TN over-door mini-truss correction

TN Corrected over-door mini-truss

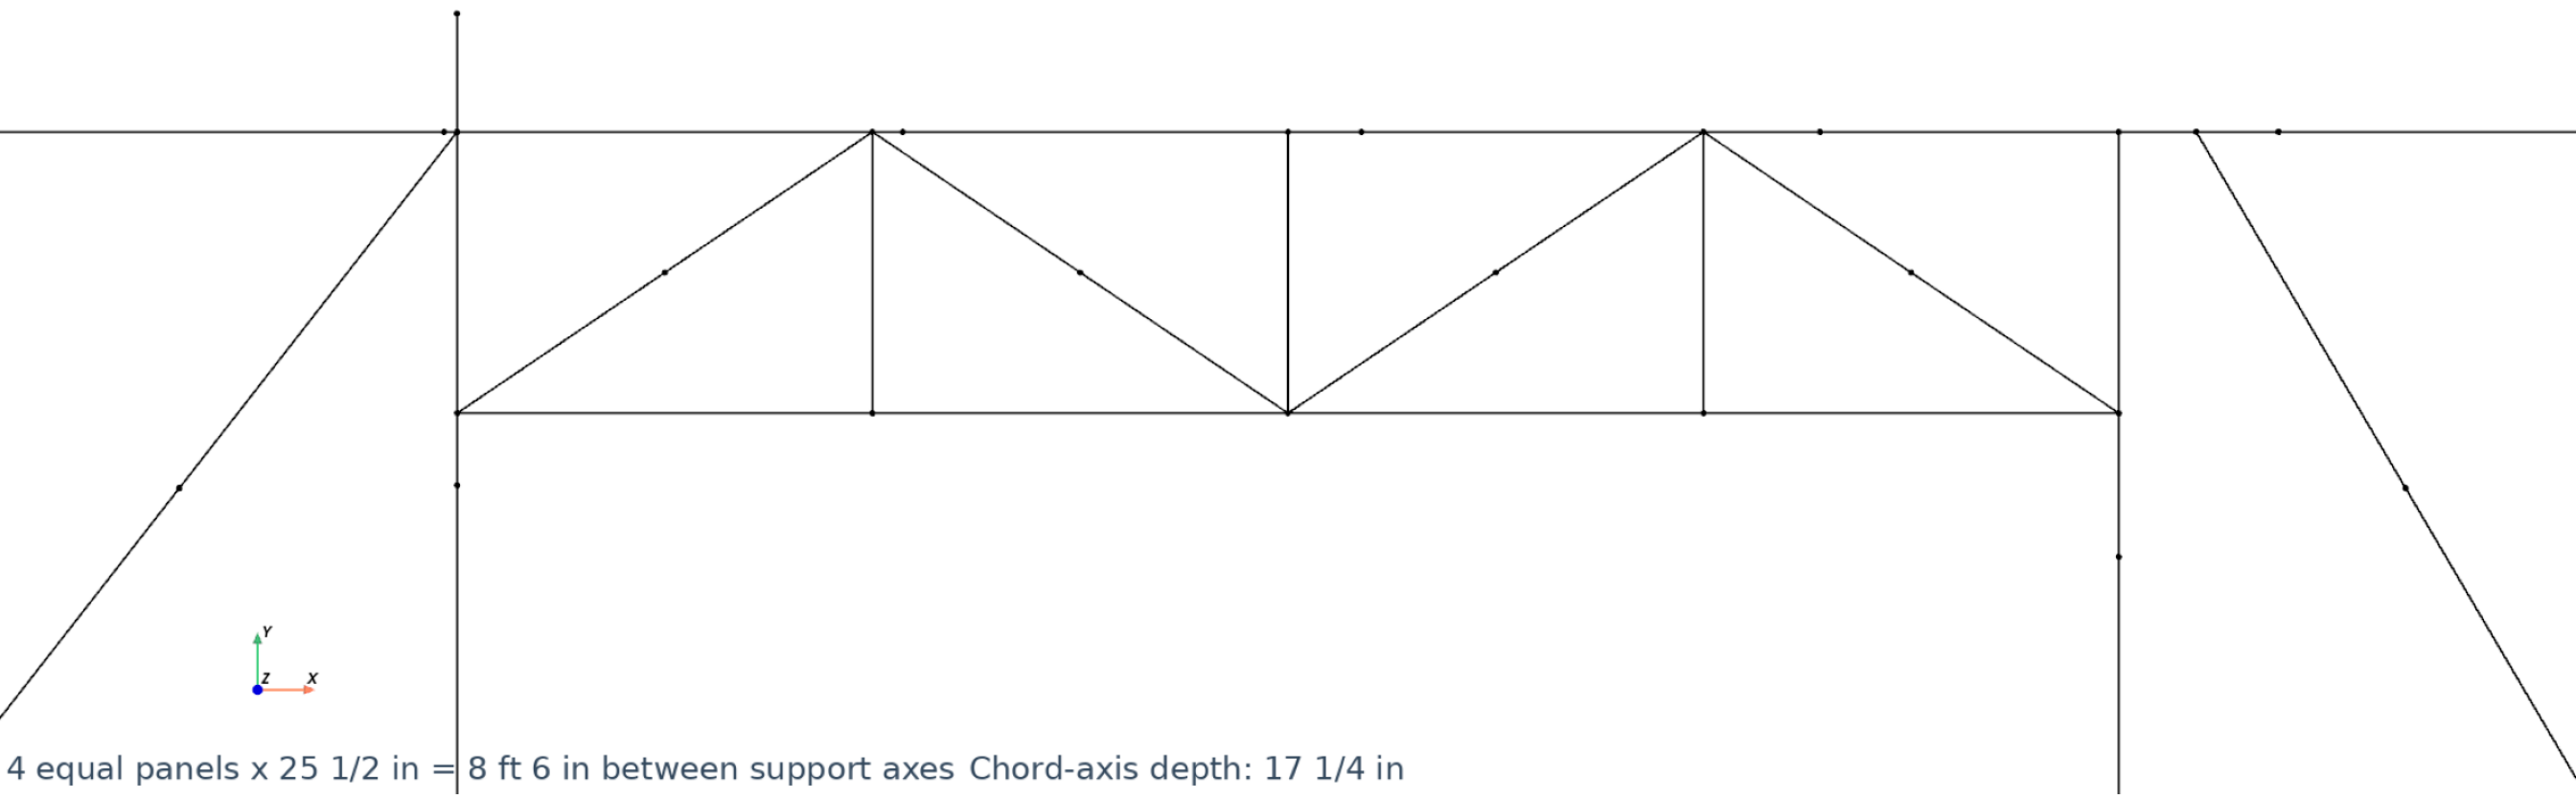
The bottom chord/header now runs level between the support axes.
Four equal 25.5-inch panels span 102 inches (8 ft 6 in) between those axes.
Chord axes are at 207 and 224.25 inches above datum: 17.25 inches apart.
These are structural centerline dimensions, not the clear finished door opening.

All mini-truss diagonals and verticals now terminate exactly on chord nodes.
The east upper jamb reaches the upper chord. The short sloping header-end connection that caused the visible uptick has been removed.

N1 / U-W is 3.5 inches north of the TN plane. Its connection is an explicit out-of-plane centroid offset, not a gap or an upward-sloping header end.
The right jamb remains above the loft; no ground post was added in the door.

TN Corrected wall elevation

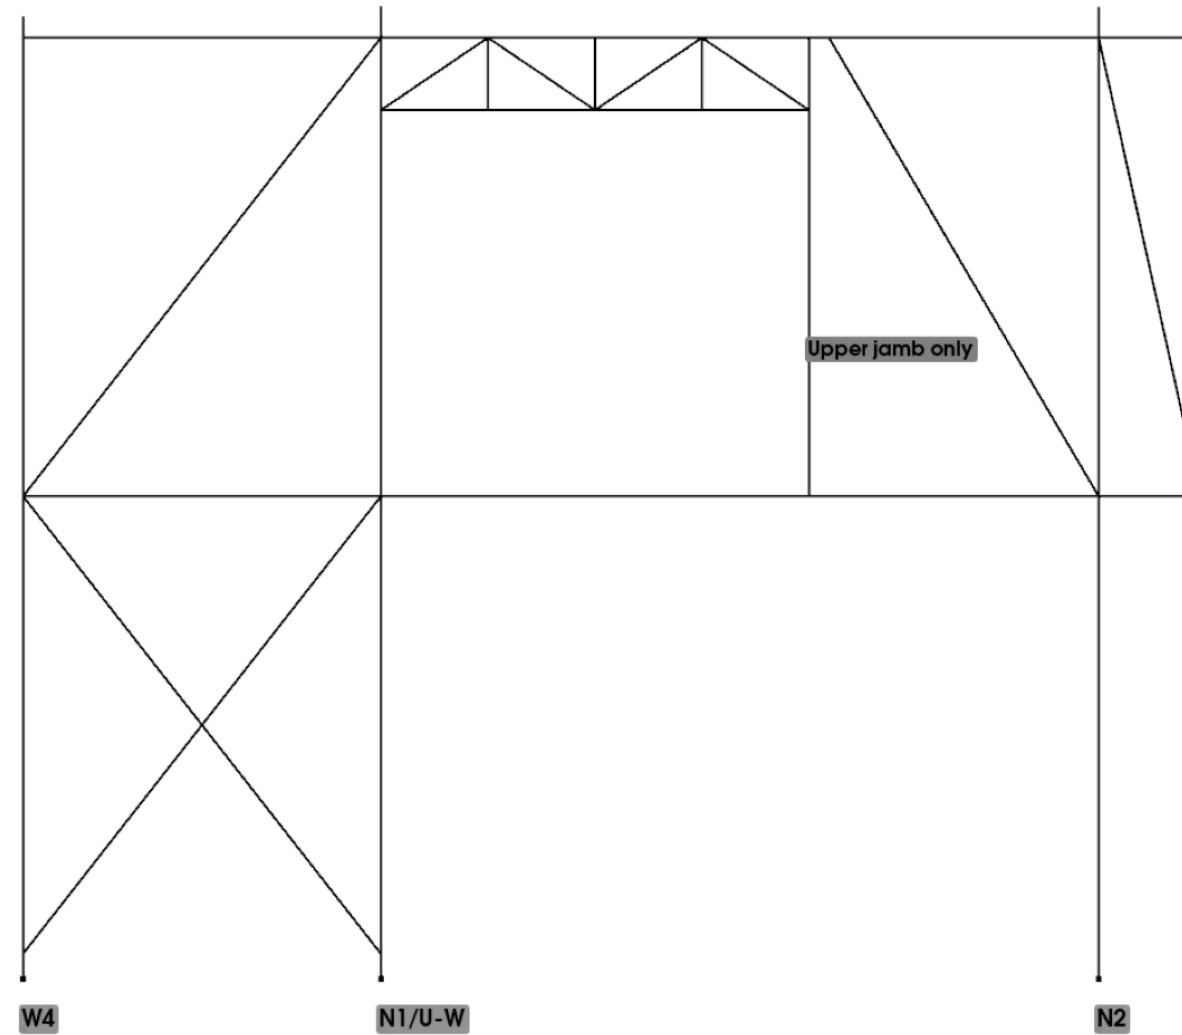
Flat upper chord axis: 18 ft 8 1/4 in
Lower chord axis: 9 ft 7 in
Overall chord run: 23 ft 5 1/2 in

Shared columns replace duplicate truss uprights. Ground-level X bracing retained.
Preliminary fixed-base model; connection and foundation design remains.

TE Corrected wall elevation

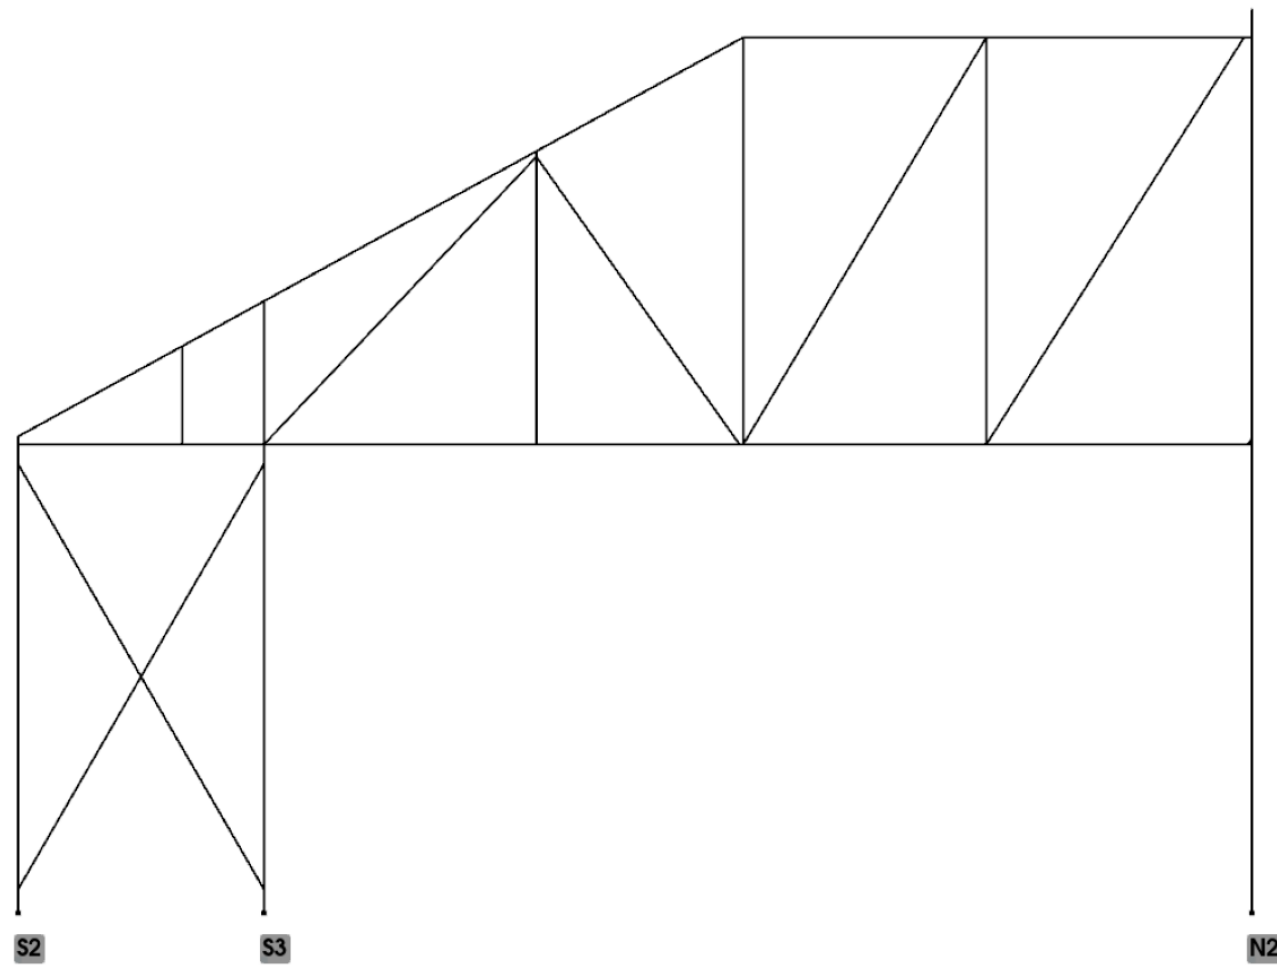
Shared columns replace duplicate truss uprights. Ground-level X bracing retained.
Preliminary fixed-base model; connection and foundation design remains.

TW Corrected wall elevation

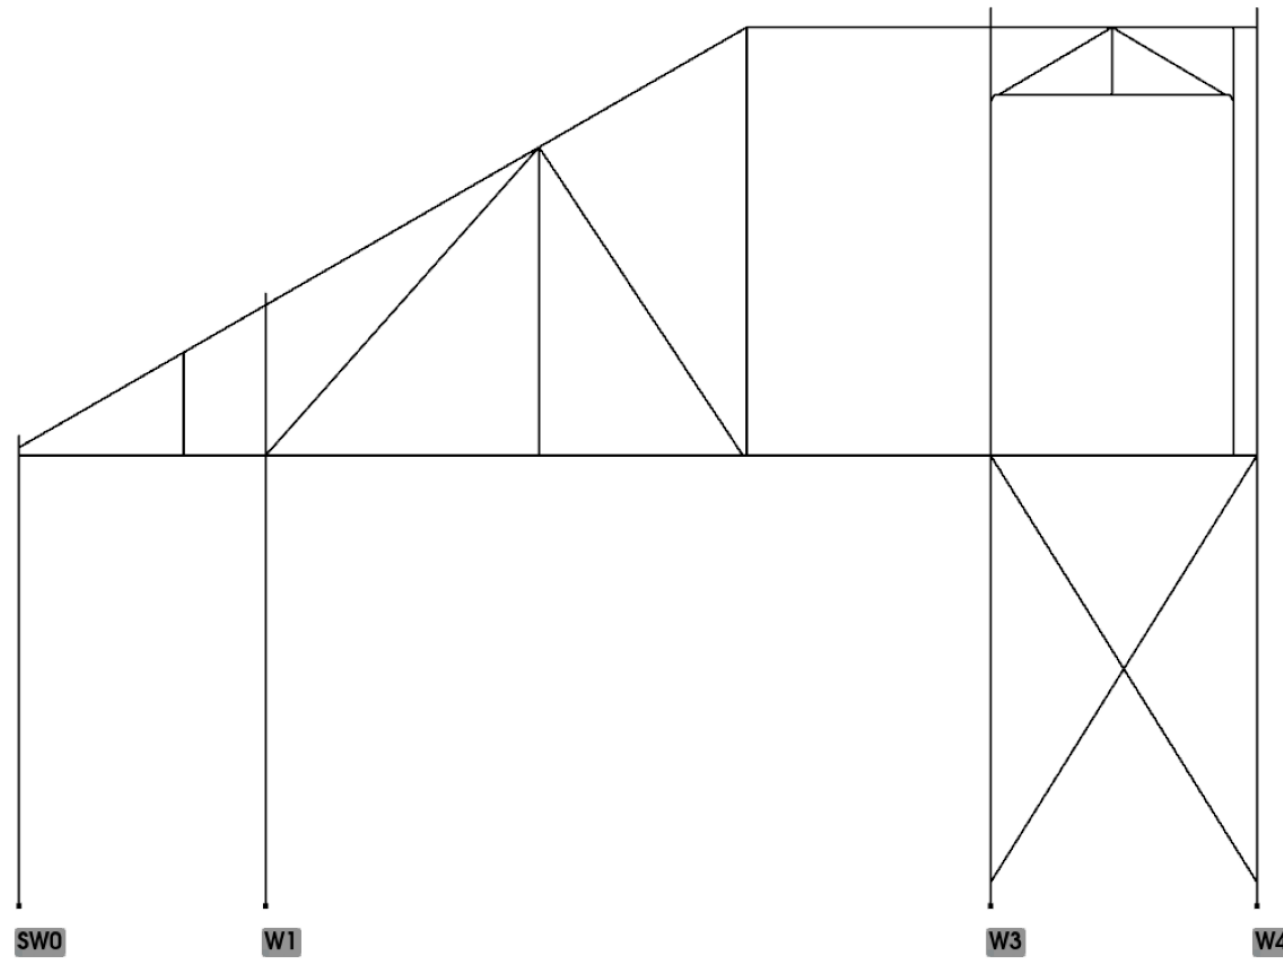
Shared columns replace duplicate truss uprights. Ground-level X bracing retained.
Preliminary fixed-base model; connection and foundation design remains.

TS Corrected wall elevation

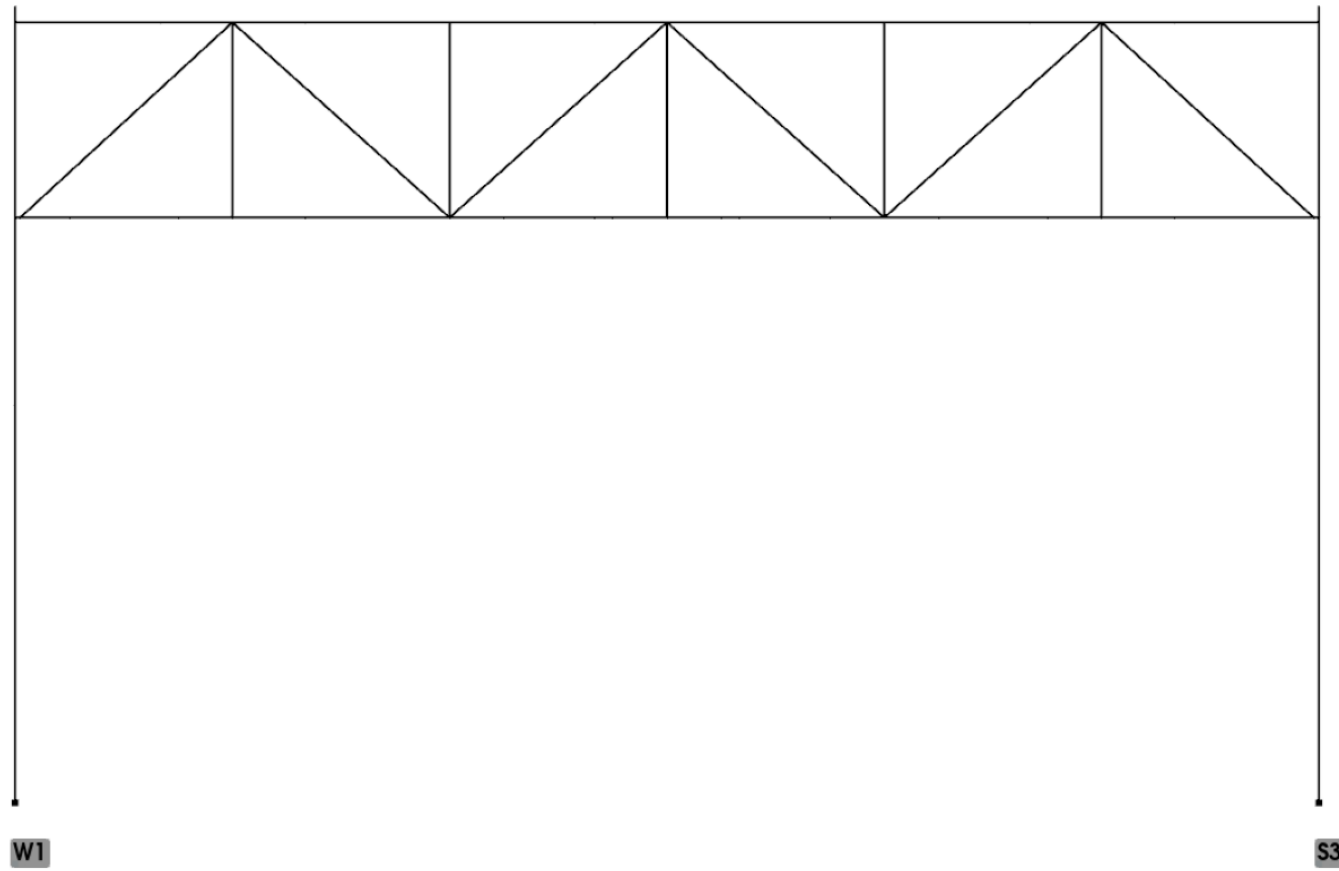
Shared columns replace duplicate truss uprights. Ground-level X bracing retained.
Preliminary fixed-base model; connection and foundation design remains.

T1 Support path

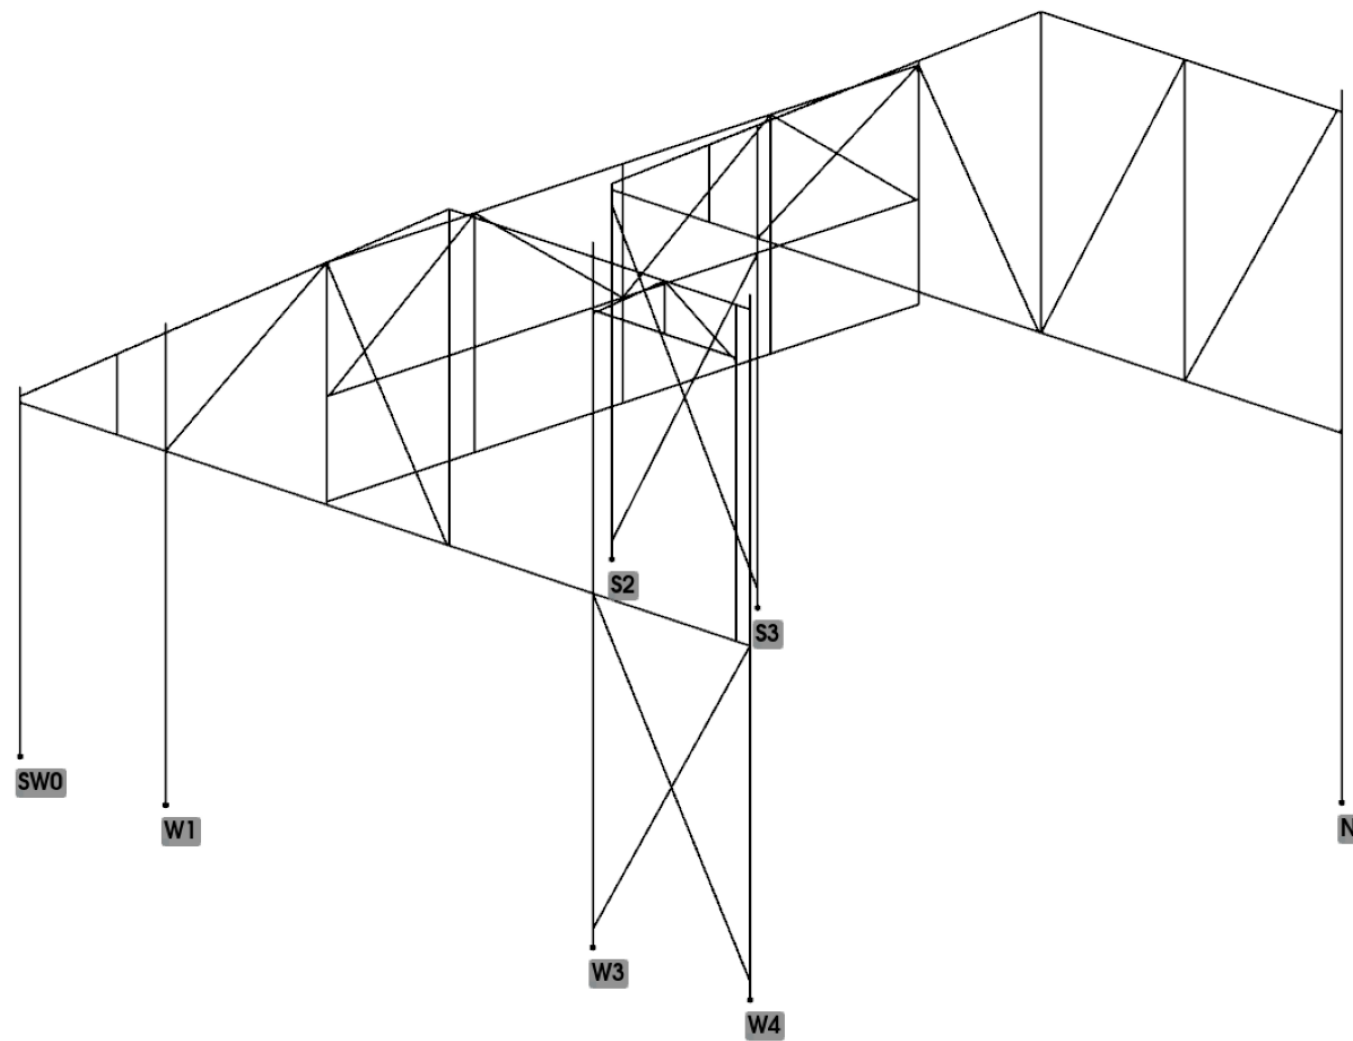
T1 bears on TE and TW; those trusses transfer its load to the ground columns.
No new posts beneath T1. This is a filtered 3D view of the globally solved frame.

ALL Support path

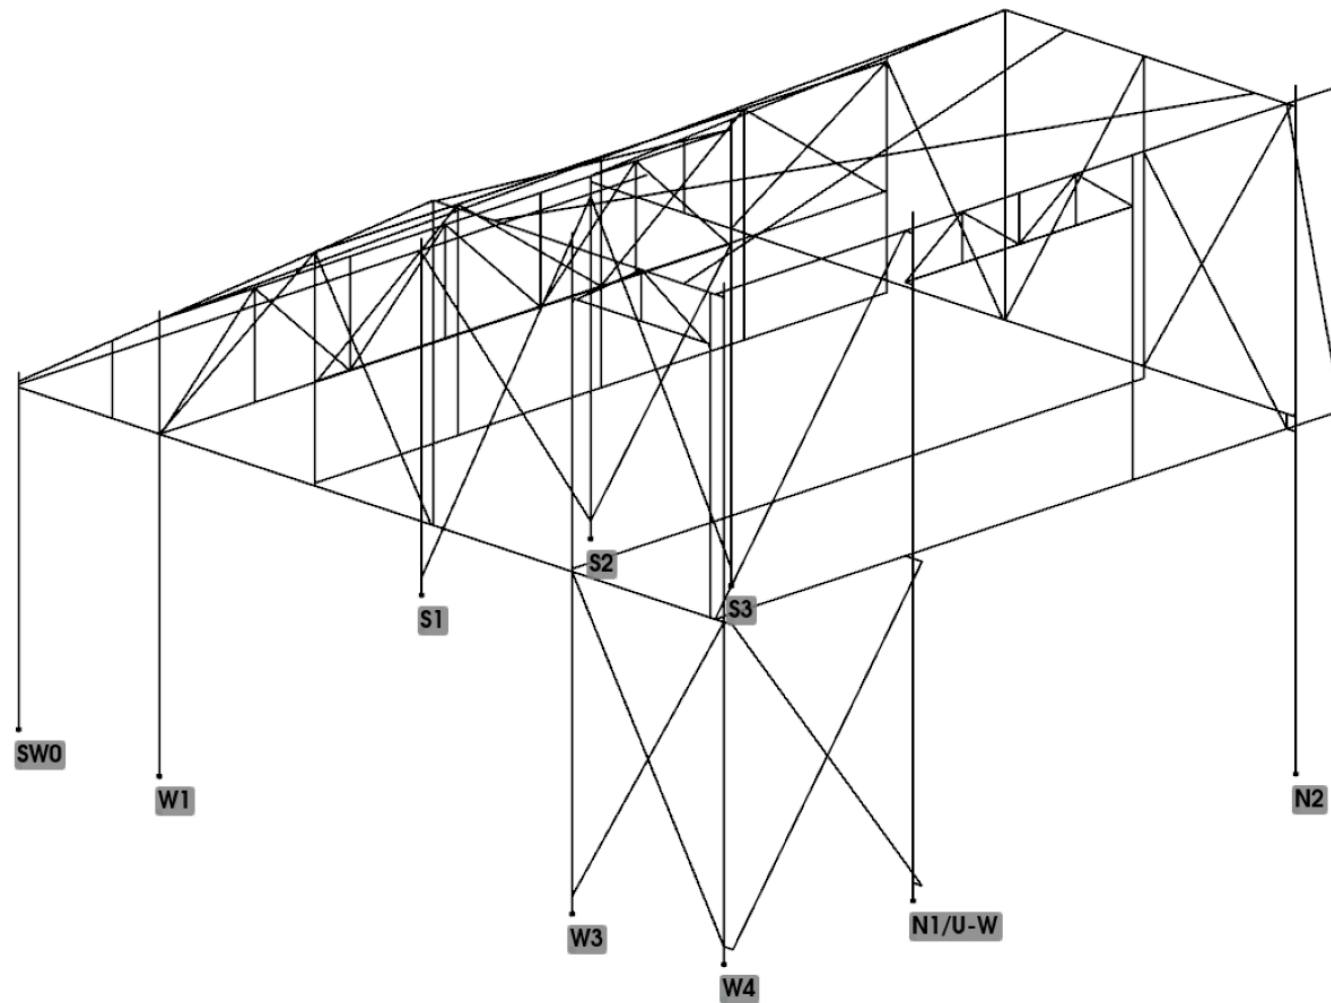
Shared columns replace duplicate truss uprights. Ground-level X bracing retained.
Preliminary fixed-base model; connection and foundation design remains.
